Technical Memo

Subject.            Measure for Coil Whine

Description.      Please paste the coil sheet on SHIELD ASSY, UPPER as measure for "Coil Whine".

COIL SHEET Pasting position

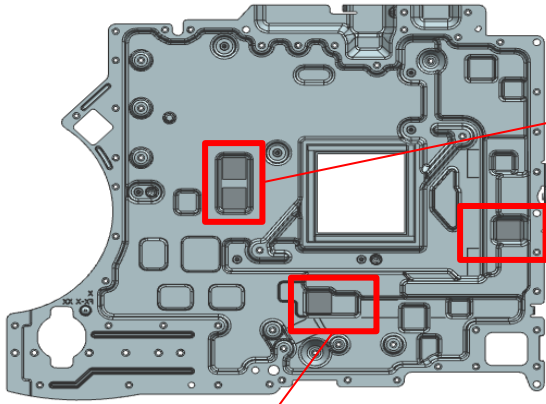
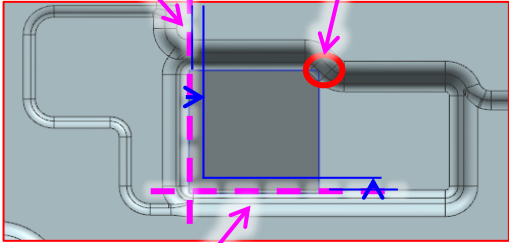
Paste the edge of the curved surface to the guide

It is NG to cover the curved surface

Upper-right corner :  
It is no matter to cover the curved surface

Vertical direction : It is OK to cover the curved surface  
Horizontal direction : It is NG to cover the curved surface

Edge of the curved surface ↔ Edge of the COIL SHEET

Paste; Gap less than 1mm

Paste HARNESS FASTENING TAPE.  
(Distinction that measure have been implemented)
